SUBJECT: Decommissioning Project Final Report 236-H, By-Product Purification Facility (V-PCOR-H-00016, Revision 1, July 22, 2025) and Savannah River Site's Responses to the Regulatory Comments on the Revision 0 Document

**SRS Draft Responses to South Carolina Department of Environmental Services
Comments on the
Decommissioning Project Final Report 236-H, By-Product Purification Facility
(V-PCOR-H-00016, Revision 0, September 9, 2024)**

**SRS Draft Responses to USEPA Comments on the Decommissioning Project Final Report
236-H, By-Product Purification Facility (V-PCOR-H-00016, Revision 0, September 9, 2024)**

Building 236-H Radiological Survey: Tritium Smear Areas

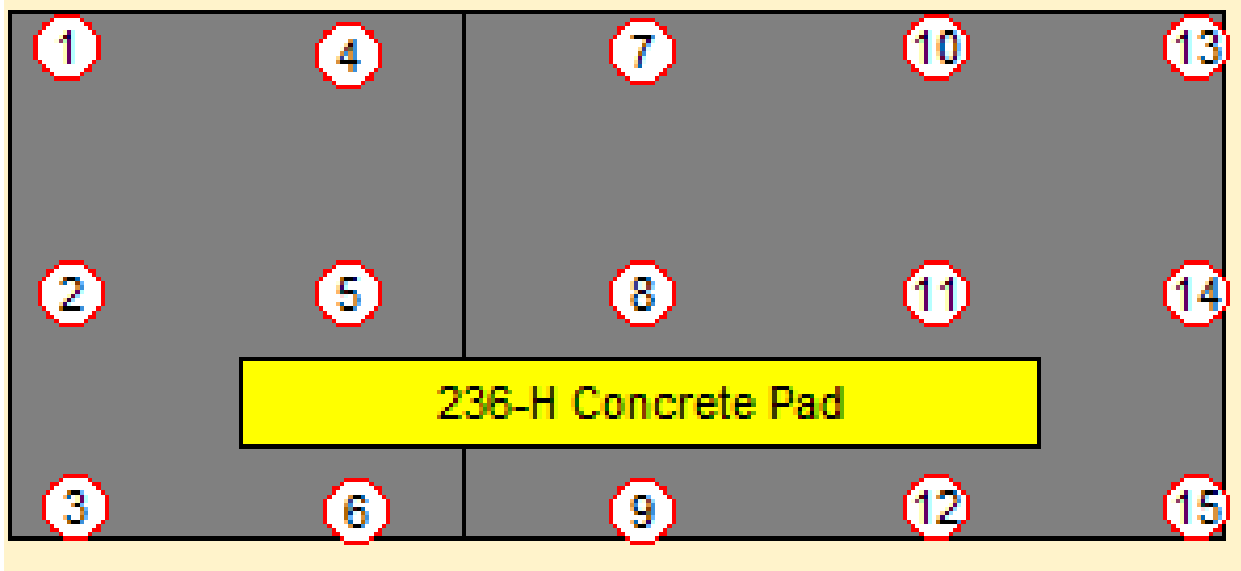
3. The DPFR does not appear to contain a figure showing the area of coverage of the radiological survey, therefore it is unclear if the slab received 100% gamma walkover survey or whether a smaller percentage was surveyed. Please revise the DPFR to include a figure that depicts the area that received the gamma walkover survey.

The radiological survey was for tritium only as it was the only radionuclide identified as a contaminant by previous surveys and concrete samples. The Building 236-H concrete slab was gridded into 15 equal areas and 5 tritium smears were collected from each area (see attached figure titled “Building 236-H Radiological Survey: Tritium

Smear Areas”). All 75 tritium smears from the 15 grided survey areas were below detection (<1,000 dpm/100 cm²). SRS proposes adding the attached radiological survey figure to the revised DPFR.
